**ONE SANSOME BUILDING**

FINAL

EE 78.334

● Changes from the text of the Draft EIR are in bold print and are indicated by solid dots at the beginning of each revised section, paragraph, line, figure or table.

● figure 33      **PROPOSED ONE SANSOME PROJECT**

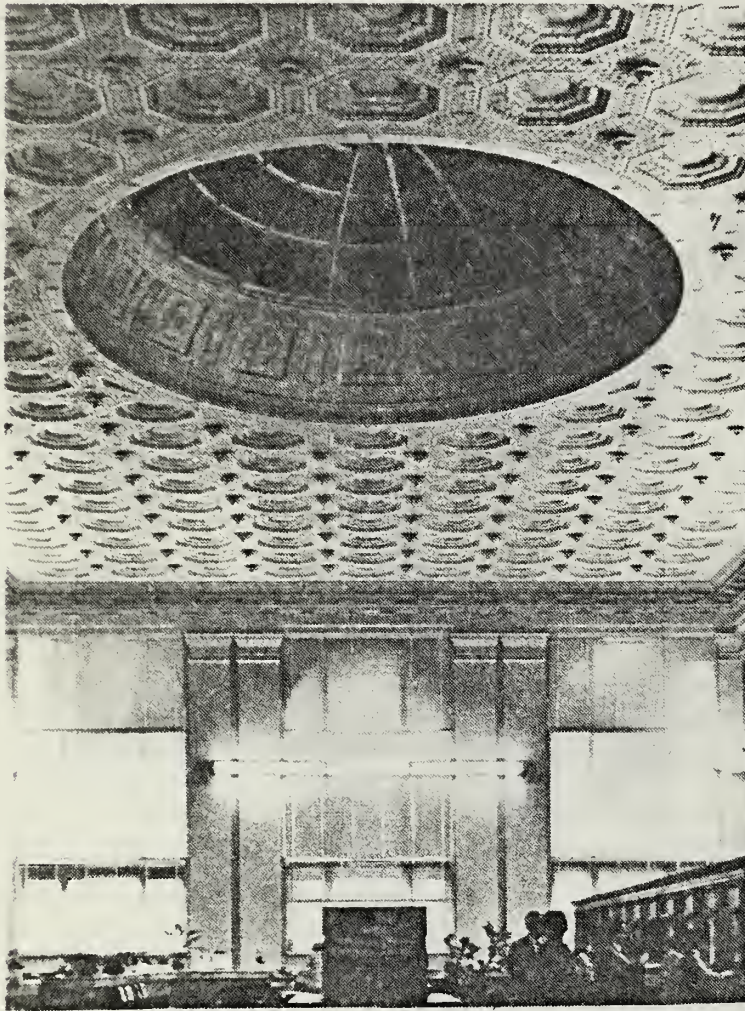
...Figure 33 on Page 69 presents a schematic diagram of the 'historic evolution' and 'proposed preservation' of One Sansome which is misleading as suggested by the statement on Page 68 that 'This (plaza) would represent a third stage in the building's historic evolution.' On the contrary, the 1981 proposed plan on Page 69, although shaded like its 'evolving' predecessors, is no longer a building. It is a plaza, according to its sponsors, without the functioning interior of a building."

Page 69. The Board objected to the inclusion of Figure 23 because this drawing implies that the project has already been built and that the proposed demolition of One Sansome has the same historic integrity of evolution as Albert Pissis' original 1908 structures and George Kelham's 1923 addition."

Figure 33, page 69, titled "Proposed One Sansome Project, Facade Preservation," was intended to illustrate the extent of demolition and proposed preservation of the existing facade in relation to previous changes to the building. The last sentence of paragraph 1 at the top of page 68 referring to the building's historic evolution has been deleted. Figure 33 has been revised to shade that portion of the site occupied by the proposed building. The shading of the proposed court

and reference to its historic evolution have been deleted (see revised Figure 33, page 9, DEIR page 69).

**figure 40**

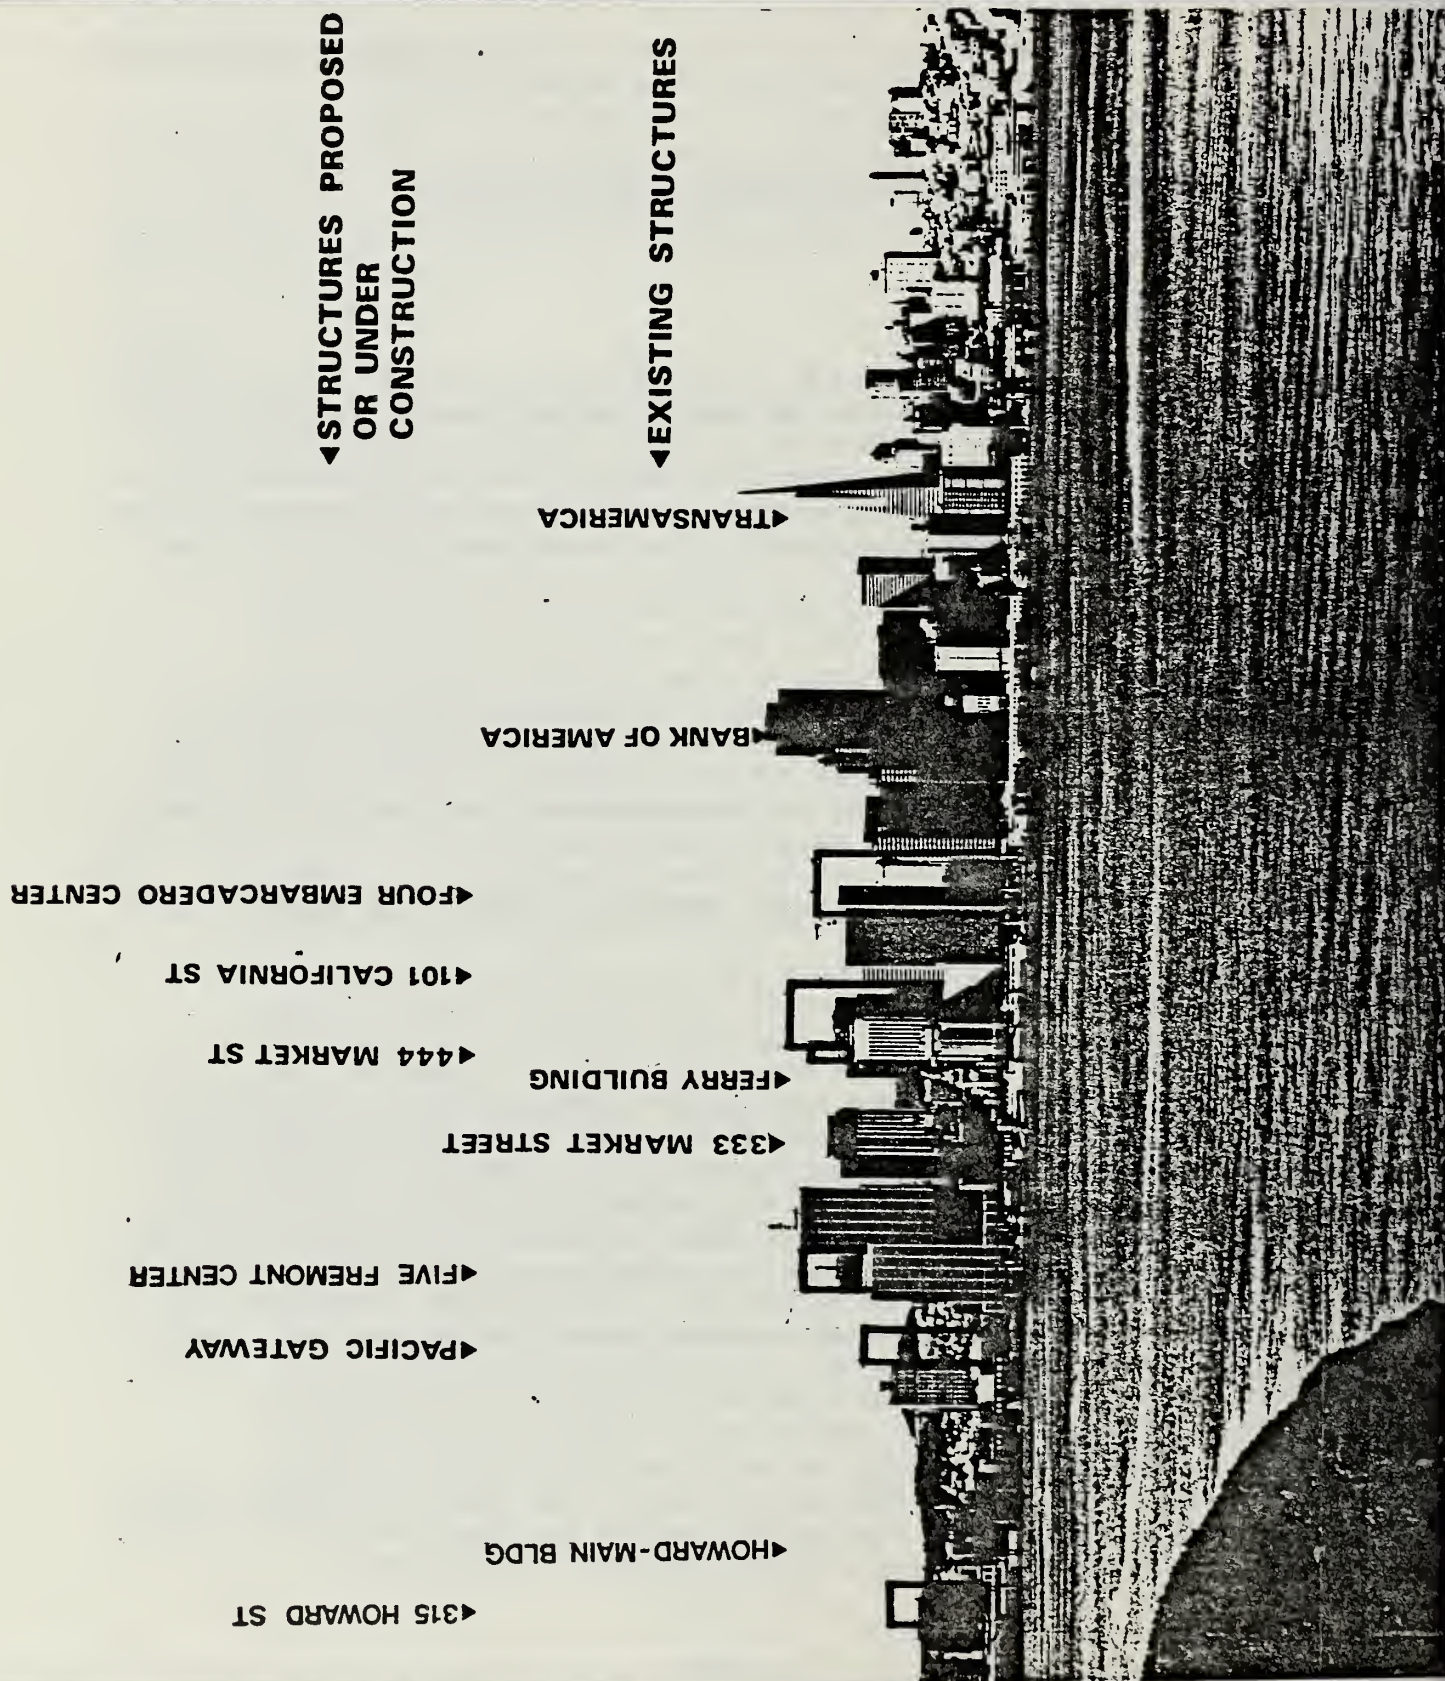
"Going to the cumulative visual impact figures -- 40, 41 -- and they're badly out of date. This EIR has been under preparation for well over a year, and I know why they're out of date. What we would like to ask them to do is to take the Planning staff's list of buildings now in the permit process and then represent them on those cumulative visual impact charts -- all of them or at least all that would be visible from that perspective."

Proposed projects at 315 Howard and Five Fremont have been added to Figure 40 on page 83; these projects would not be visible in the view depicted in Figure 41. Other projects approved as of the date of the DEIR would not be visible in the views depicted in Figure 40 or Figure 41 (see revised Figure 40, page 13, DEIR page 83).

figure 7

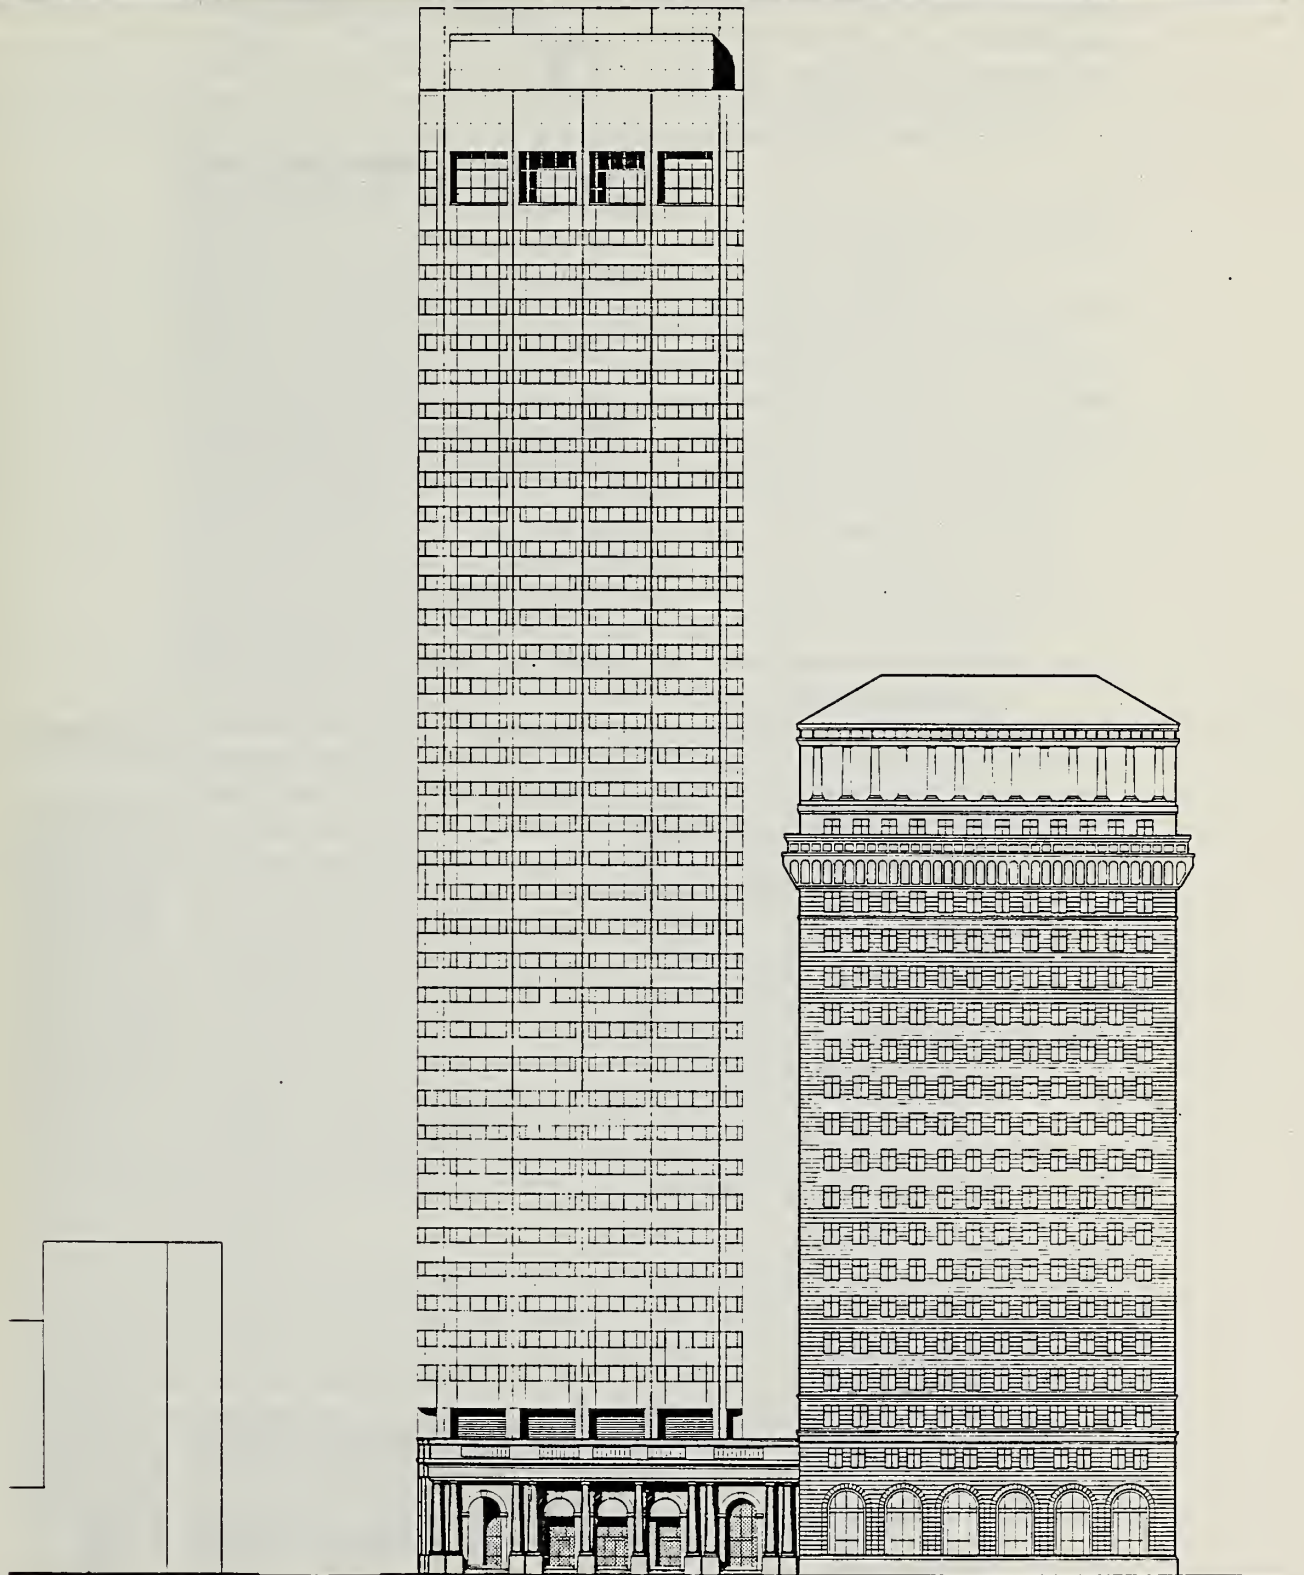
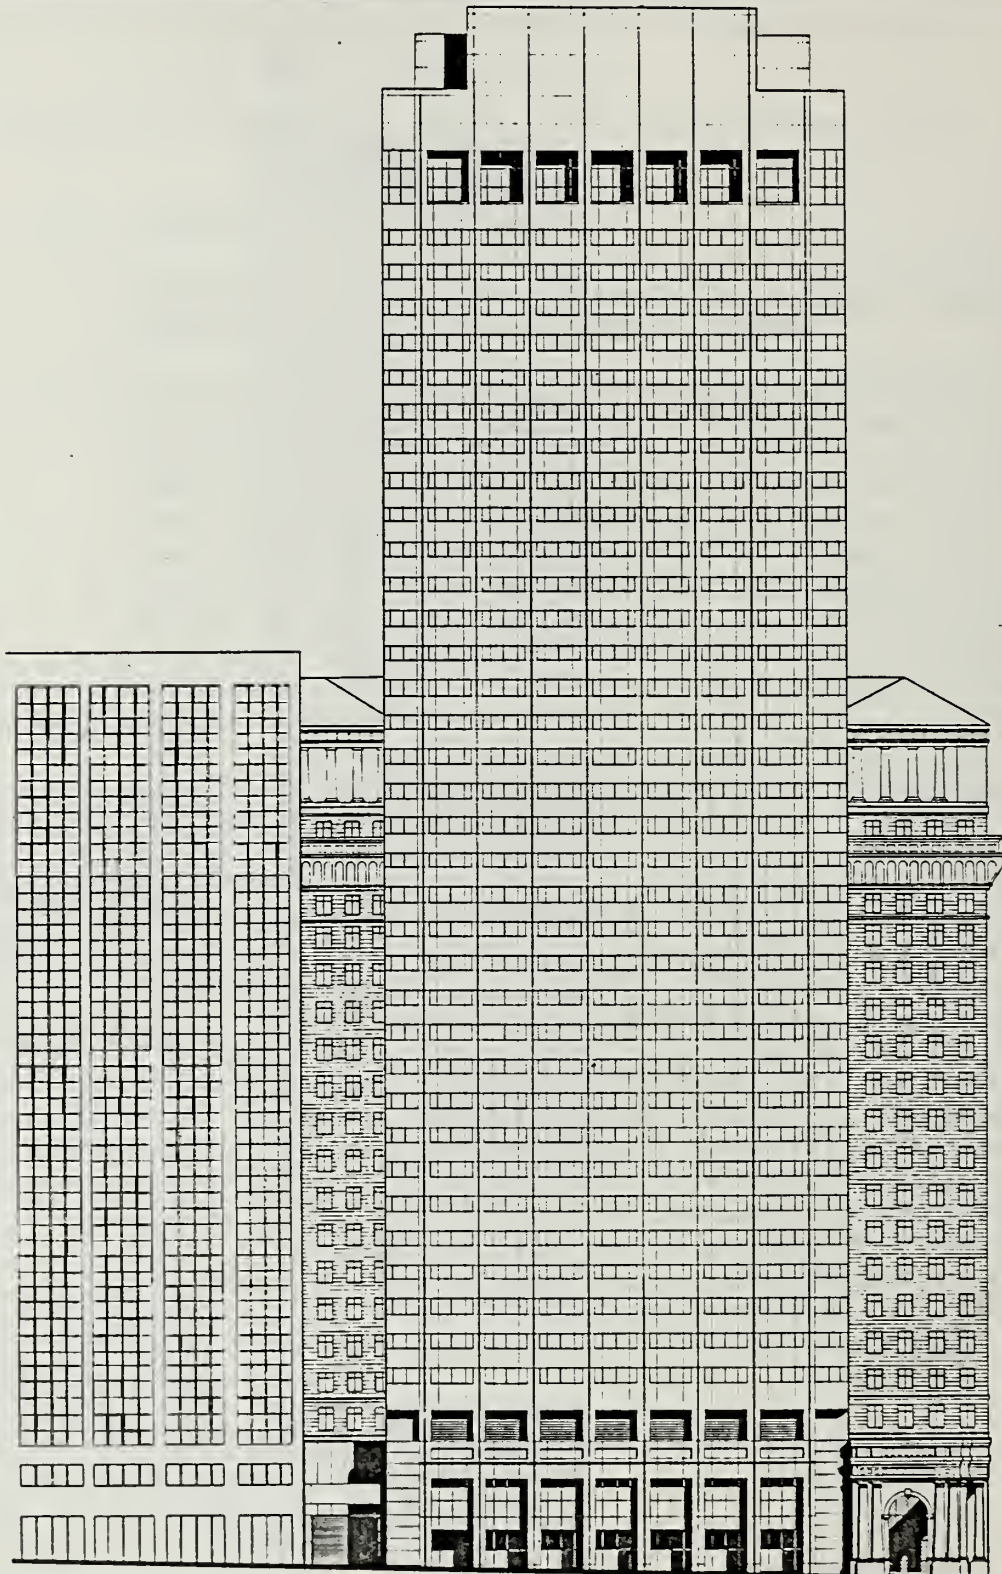
"...In the Urban Design section... it's a very large project, very much like the other large shoe boxes standing in a row on Market Street, and there's a real question whether this kind of design -- and it would be the third floor through fifth one depending on how you want to look at it -- is really appropriate for that location; whether this size bulk, this kind of mass of structure is really appropriate for this spot. You have already buried Market Street under a whole row of them, and the benefits of adding one more should be looked at closely.

...This building being so large...the nature of [the] facade is really a critical consideration...they're going to have ...solar gray glass and a precast concrete panel sticking out the same color as the One Sansome Building. It's hard to say if that's going to be a good design. A lot depends on the quality of the concrete work. Is there going to be any design expression in that concrete work? Are they going to be flat panels? It appears it's going to be a rather dull, boring, very big expanse of concrete and glass...

What we would like to see is some mitigation described that does much better work. There has been some good concrete work done in San Francisco. I don't see why other architects can't live up to that standard..."

Since publication of the DEIR, the roof profile of the tower has been modified considerably to create a distinctive "step" on the east and west sides, revealing a curved sculptured mechanical enclosure (See revised Figures 7 and 8, pages 56 and 57, DEIR pages 16, 17). The use of granite for the lower floors, to match the existing One Sansome Building, is presently under consideration.
